MAR401/403 and MAFR401/403 Series

Bracket Design Change Notification

Before	After
Appearance		
Dimensions		
Bracket	B1-MAR401 	B2-MAR401

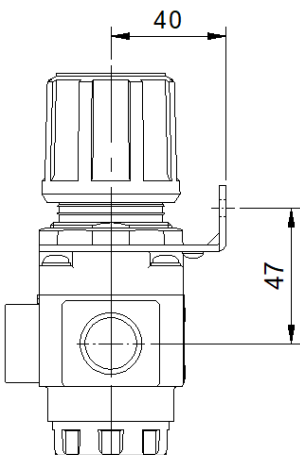
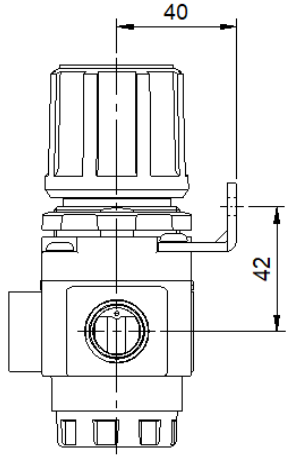
Due to the market feedback, the bracket design retains the original screw fixed type. The nut fixed type bracket (B1-MAR401) is according to specific customer needs to order.

Take MAR401 series for example.
